# ADDENDUM NO. 1

## 14<sup>th</sup> Street (Madison to Woodburn) Sidewalk Project

**Issue Date:** November 13, 2020

title: LINE PR-1 PLAN & PROFILE

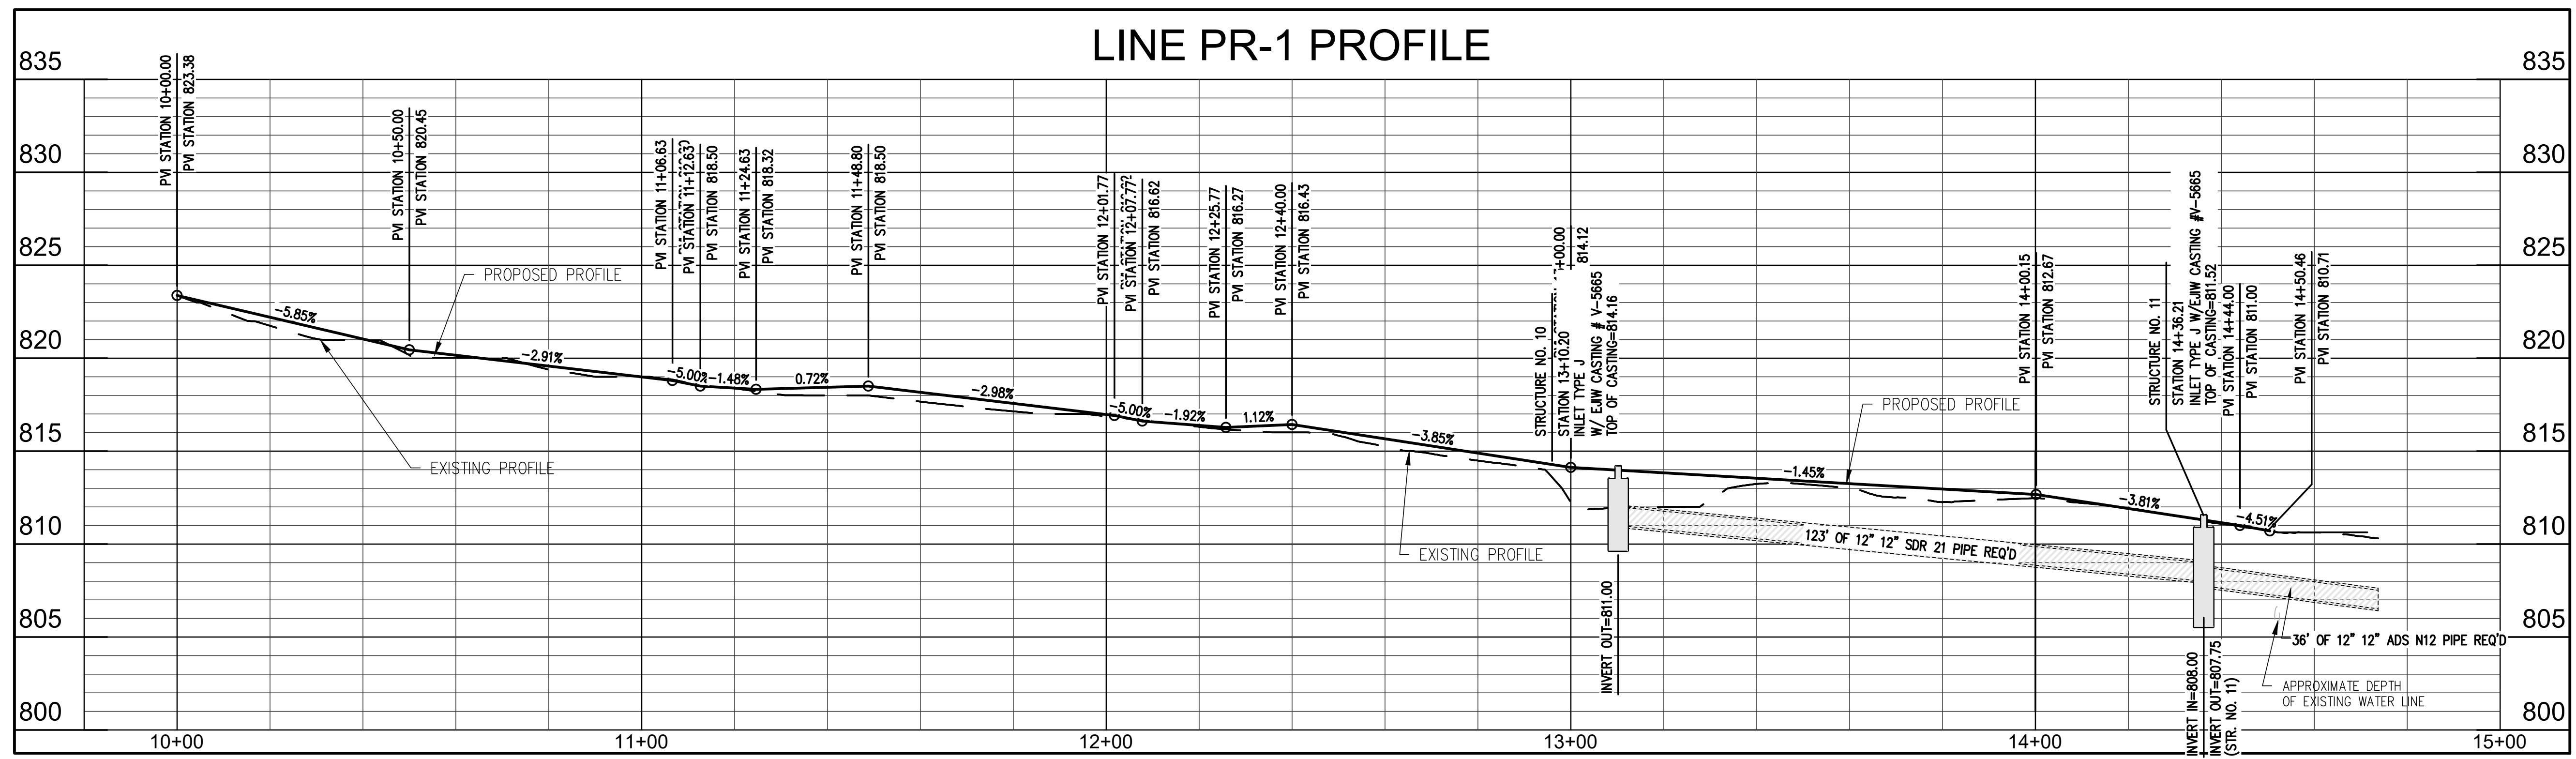
**Item No. 1:** A revised "14<sup>th</sup> Street (Madison to Woodburn) Sidewalk Plan and Profile" Sheet C201, has been issued and is attached to the addendum. The project shall be built as shown on the revised sheet.

revisions:  
 11-10-20 - REVISED PIPE FROM STR 10 TO STR 11 TO SDR 21
